COUNCIL ASSESSMENT PANEL MEETING

THURSDAY, 16 APRIL 2026 AT 6:00 PM

5.1 CONSTRUCTION OF RETAINING WALLS WITH FENCING ABOVE (COMBINED HEIGHT VARYING BETWEEN 2.6M AND 3.8M), RETROSPECTIVE RETAINING WALLS, TUBULAR FENCING AND STEPS

Figure 7 – Annotated Site Plan

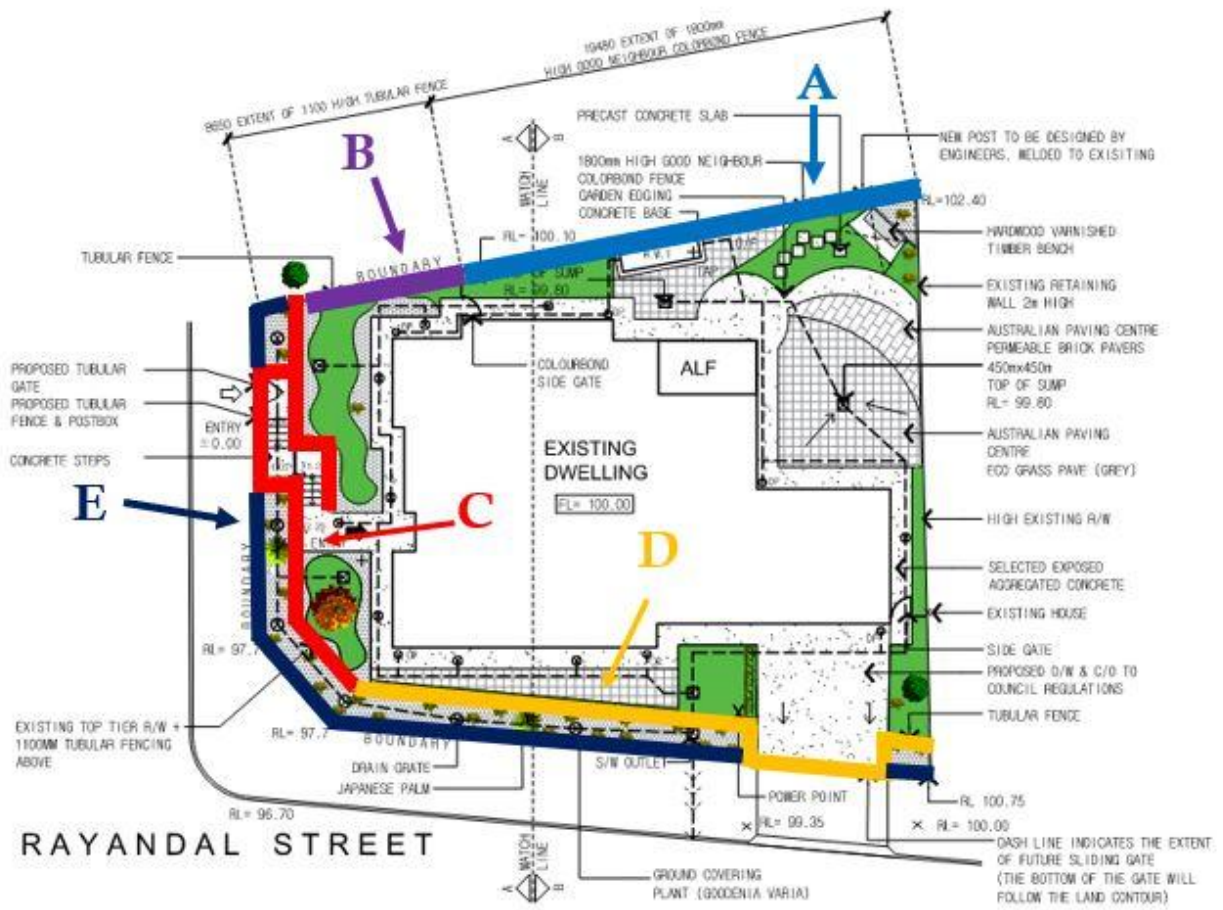
- 1.8m high Colorbond ‘Good Neighbour’ fencing (Monument colour) and retaining wall along part of the northern boundary, with a combined height varying between 2.6m and 3.8m.
 - *Note – proposed to replace the existing retaining wall and fencing. Previously approved as a terrace retaining wall (with a maximum total height of 2m)*
 - *Refer to ‘A’ on Figure 7: Annotated Site Plan*

- 1.1m high tubular fence along the northern boundary forward of the existing dwelling line and associated retaining walls (retrospective) to a maximum height of 1.2m.
 - *Refer to 'B' on Figure 7: Annotated Site Plan*
 - *Refer to Figure 8 showing northern elevation*
 - *Refer to image in Figure 3*

Along the northern boundary, the existing retaining walls and fencing are proposed to be removed and replaced with new retaining walls and 1.8m high Colorbond 'Good Neighbour' fencing. While both the existing and proposed retaining walls and fencing

Importantly, the northern boundary retaining walls are located away from the Norway Avenue and Ryandal Court frontages, and the full extent of these structures are largely screened by the existing single storey dwelling. As a result, they do not present an unreasonable visual impact upon the streetscape.

Figure 8 – Northern elevation

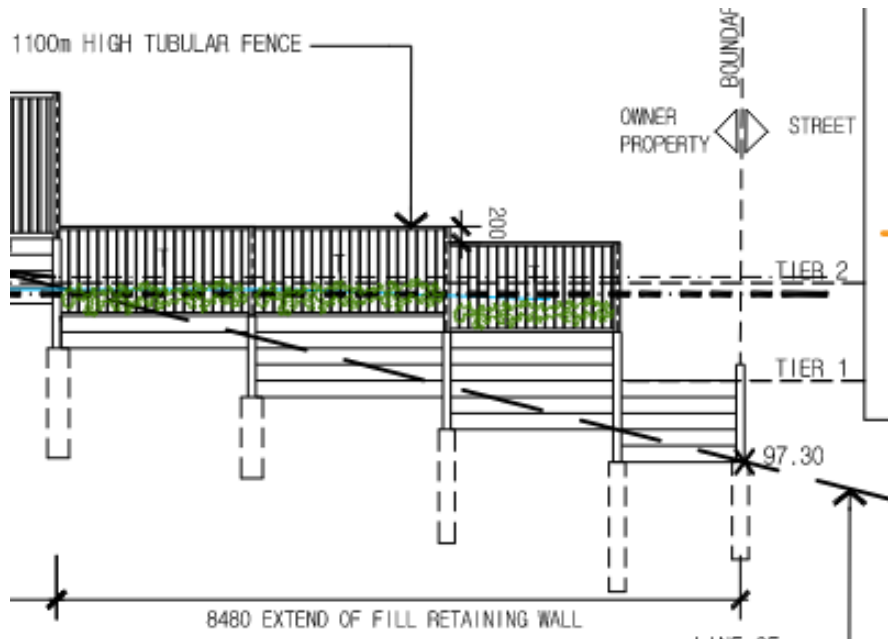
The upper stepped retaining walls, located closer to the dwelling, incorporate an additional 1.1m high open tubular fencing. This fencing functions in a similar manner to balustrading, providing safety and security for occupants while maintaining an open and visually permeable form that minimises visual bulk. The use of open-style fencing ensures that views across the site are maintained and that the development does not present as an overly solid or visually dominant structure when viewed from the street.

Figure 10 – Northern elevations

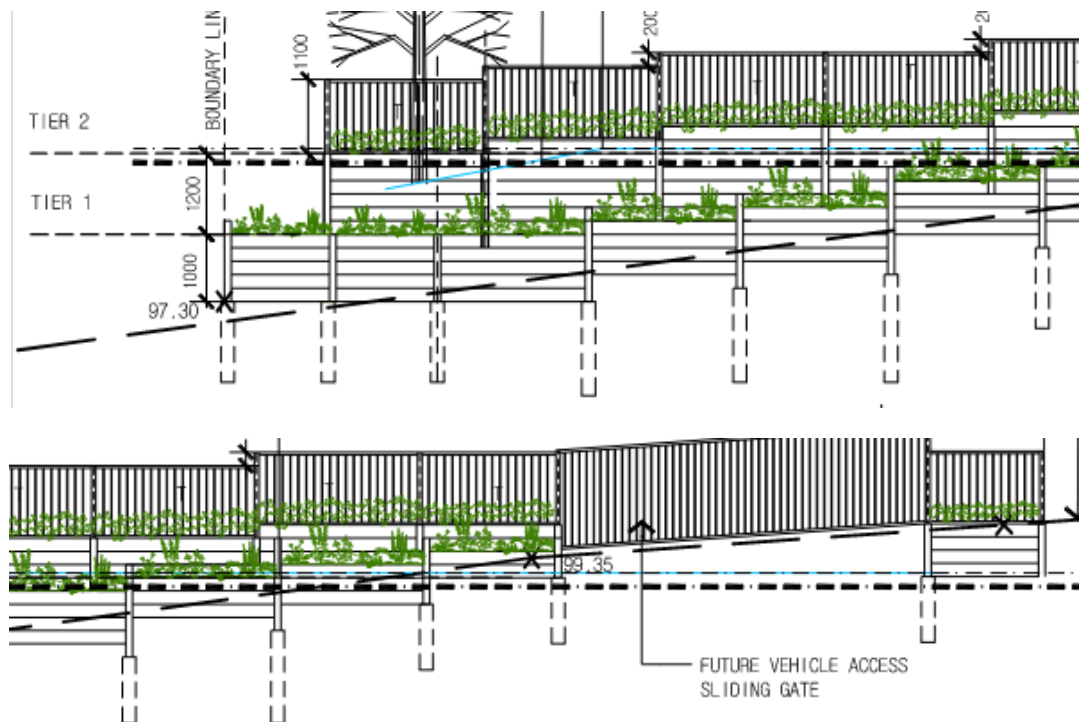
along this boundary exceed the guidance of PO 11.3 of the Hills Neighbourhood Zone, the departure is not considered to undermine the intent of the Zone or PO 9.1 of the Design in Urban Areas General Development Policies.

Furthermore, the subject land has been cut to establish a level building platform, resulting in the height of the retaining structure when viewed from the adjoining property being significantly reduced. Only a limited portion of the retaining wall is visible, with the fencing forming the most prominent element. This design approach reduces the perceived scale of the structure and assists in limiting potential visual impacts on the adjoining landowner. In addition, the northern boundary forward of the dwelling has been amended to incorporate 1.1m high open tubular fencing (rather than 1.8m Colorbond fencing), which assists in maintaining lines of sight between adjoining properties and the street frontage. This treatment provides a more open streetscape presentation while continuing to provide an appropriate delineation of the allotment boundary.
